Informal document No. GRSP-46-01
(46th GRSP, 6 - 9 December 2009,
agenda item 13)

Proposal for revision of UN ECE Regulation No 29

**UNIFORM PROVISIONS CONCERNING THE APPROVAL OF VEHICLES
WITH REGARD TO THE PROTECTION OF THE OCCUPANTS
OF THE CAB OF A COMMERCIAL VEHICLE**

Model B

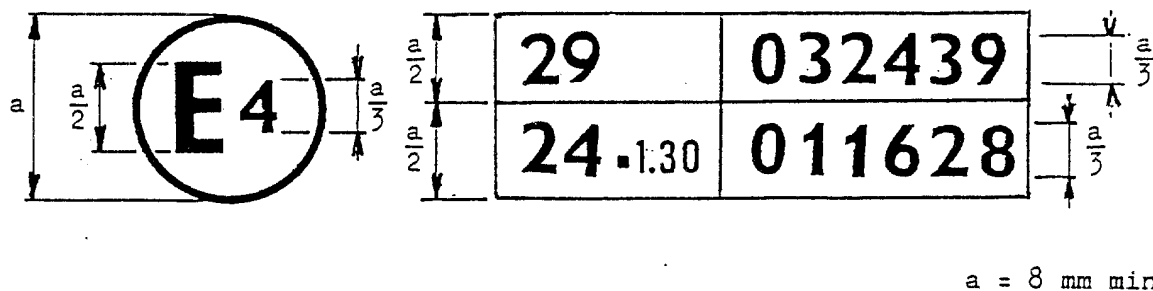
The above approval mark affixed to a vehicle shows that the vehicle type concerned has been approved in the Netherlands (E 4) pursuant to Regulations Nos. 29 and 24 ^{1/}. (In the case of the latter Regulation the corrected absorption coefficient is 1.30 m^{-1}). ~~The cab of the vehicle meets the requirements of test C.~~ The approval numbers indicate that on the dates on which these approvals were granted Regulations Nos. 29 and 24 included the ~~03 02~~ series of amendments.

Fig. 1 – Front impact test (test A).

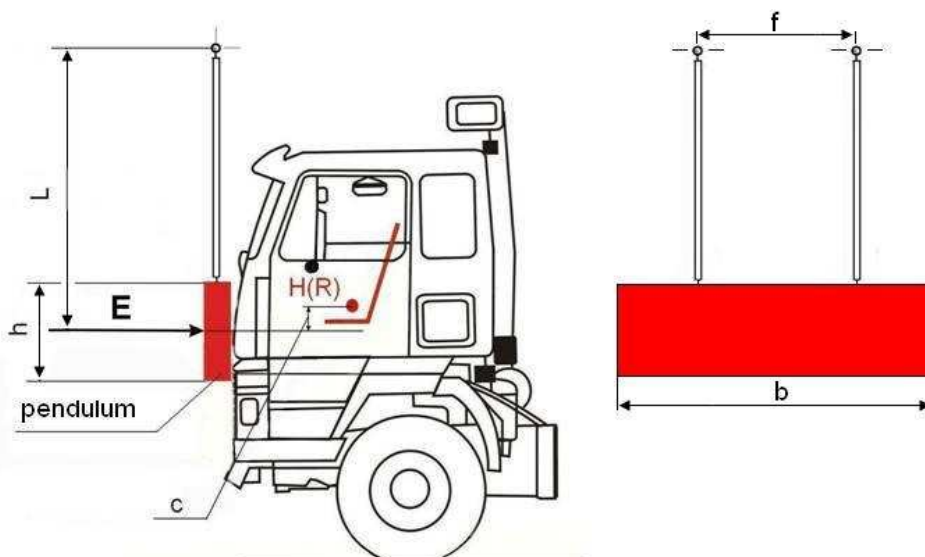
- 5.1. The **impactor swing-bob** shall be made of steel and its mass shall be evenly-distributed; its mass shall **not be less than 1,500 ± 250 kg**. Its striking surface, rectangular and flat, shall be 2,500 mm wide and 800 mm high (**see b and h on Figure 1**). Its edges shall be rounded to a radius of curvature of not less than **[1.5]** mm.

- 5.2. The **impactor swing-bob** assembly shall be of rigid construction. The **impactor swing bob** shall be freely suspended by two beams rigidly attached to it and spaced not less than 1,000 mm apart (**see f on Figure 1**). ~~The beams shall be of "I" section with a web height of not less than 100 mm or shall be of a section having at least an equivalent moment of inertia.~~ The beams shall be not less than 3,500 mm long from the axis of suspension to the geometric centre of the ~~bob~~ **impactor (L on Figure 1)**.

- 5.3.2. its centre of gravity is $c=50 +5/ - 0$ mm below the R point of the driver's seat, and
 - 5.3.3 its centre of gravity is in the median longitudinal plane of the vehicle.

- 5.5 The impact energy shall be:
 - 5.5.1 ~~29.4 kJ 3,000 mkgf for vehicles of a permissible maximum mass up to 7,000 kg and 4,500 mkgf for vehicles for which the permissible maximum mass exceeds this value~~ **in the case of vehicles of category N1 and of vehicles of category N2 with a gross vehicle mass not exceeding 7.5t.**

- 5.5.2 **55 kJ in the case of vehicles of category N3 and of vehicles of category N2 with a gross vehicle mass exceeding 7.5t.**

Fig. 2. – Front pillar impact test (Test B).

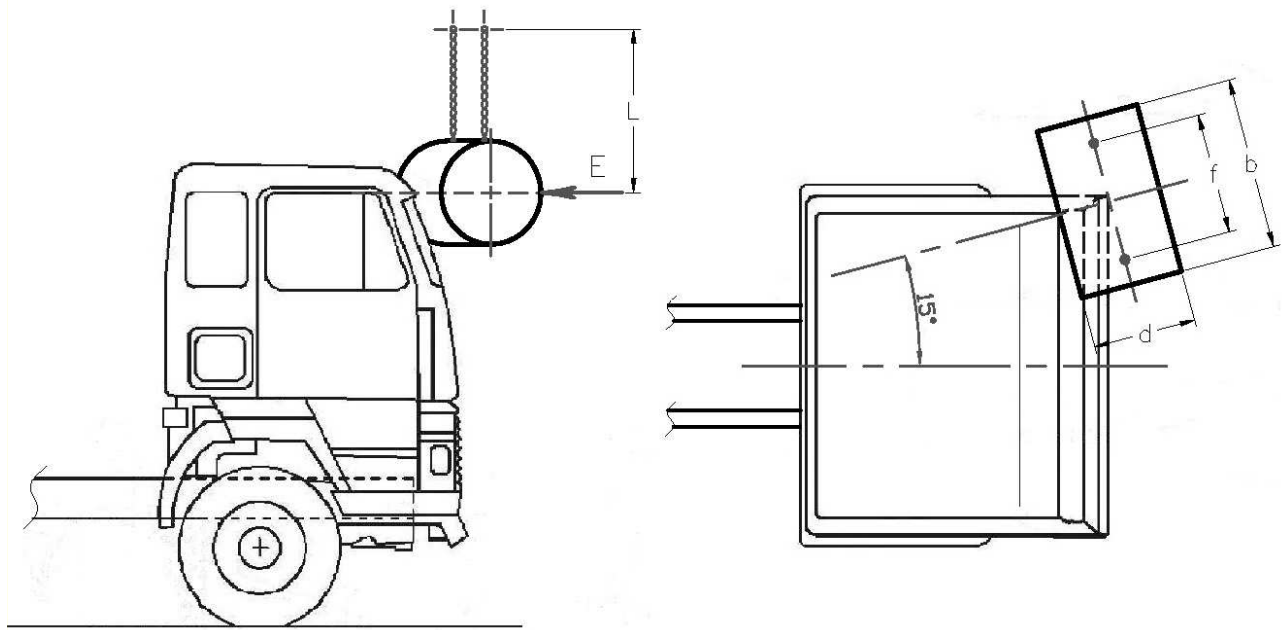
- 6.1. The impactor shall be rigid [~~be made of steel~~] and its mass shall be evenly-distributed; its mass shall not be less than 1,000 kg. The impactor shall be cylindrical with a diameter d of the cylinder of 600 $[\pm 50]$ mm and a length b of ~~not less than 2,500 mm~~ **1000 mm**. Its edges shall be rounded to a radius of curvature of not less than [15] [1.5] mm.

- 6.2. The impactor assembly shall be of rigid construction. The impactor shall be freely suspended by two beams **chains** rigidly attached to it and spaced not less than $f = 1,000$ **700** mm apart. The beams shall be of "I" section with a web height of not less than 100 mm or shall be of a section having at least an equivalent moment of inertia. The beams **chains** shall not be less than $L = 3,500$ mm long from the axis of suspension to the geometric centre of the ~~bob~~-impactor.

- 6.3.2. ~~its median longitudinal line is horizontal and perpendicular to the median longitudinal vertical plane of the cab;~~
the point of contact between the pillar of the cab and the impactor is in the median transverse plane of the impactor;

- 6.3.3. ~~its center of gravity point of contact between the cylinder and the median longitudinal vertical plane of the cab is midway between the lower and the upper windscreen frame, as measured along the windscreen and along the median longitudinal vertical plane of the cab;~~

the centre of gravity of the impactor is 100 mm lower than the upper horizontal edge of the door aperture;

6.4. The impactor shall strike the cab at the front in the direction towards the rear of the cab. The direction of impact shall be horizontal and shall be parallel to the median longitudinal plane form an angle of 15° to the median vertical longitudinal plane of the vehicle (See Fig. 2);

Fig. 3. Roof strength test (Test C).

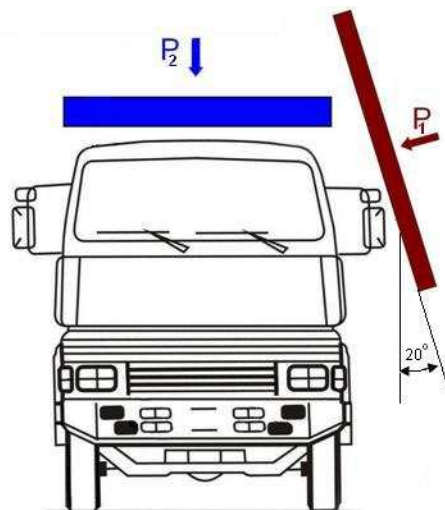
7.3 Dynamic pre-loading of vehicles of category N2 with a gross vehicle mass exceeding 7.5t and of category N3 (see P_1 on Figure 3).

- 7.3.3.** The impactor and/or the cab shall be so positioned that, at the time of impact:
- 7.3.3.1.** the striking face of the impactor is at an angle of 20° to the median longitudinal plane of the cab; either the impactor or the cab may be tilted

- 7.3.5.** The impact energy shall be minimum 17.6 29.4 kJ.
- 7.4.** Roof strength test (see P₂ on Figure 3)
- 7.4.1.** The loading device shall be made of steel and its mass shall be evenly distributed.

- [**7.4.3.** A linear bearing system shall be included between the device and its supporting structure to allow for lateral motion of the cab roof away from the side that was impacted in the pre-load phase of paragraph 6.3. 7.3., if applicable.]

Fig. 4. – Rear-wall strength test

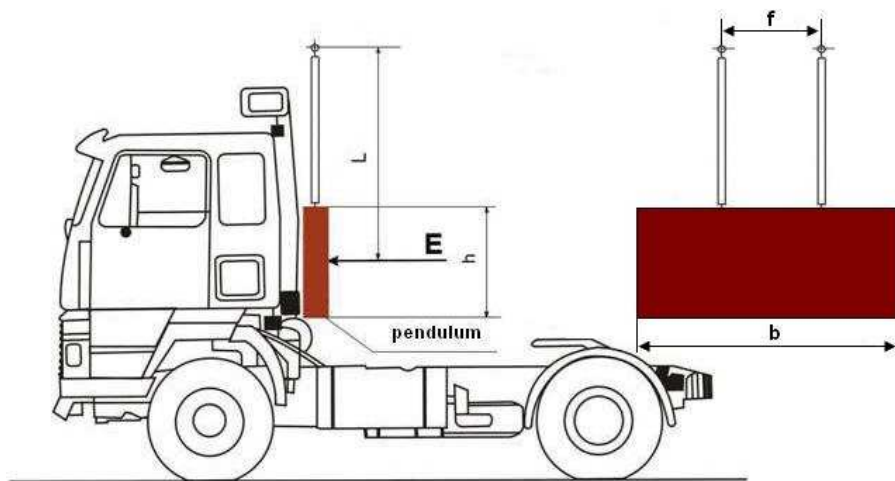
[8. Rear-wall strength test (test C D)

8.1.4. A static load of **1.96 kN** ~~200 kgf~~ per ton of permissible useful load shall be applied by the loading device to the rear wall of the cab

8.2. Vehicles of category N2 with a gross vehicle mass exceeding 7.5t and of category N3 (see Figure 4)

8.2.1. The impactor shall be made of steel and its mass shall be evenly-distributed; its mass shall not be less than 1,500 kg. Its striking surface, rectangular and flat, shall be $b = 2,500$ mm wide and $h = 800$ mm high. Its edges shall be rounded to a radius of curvature of not less than [15] mm.
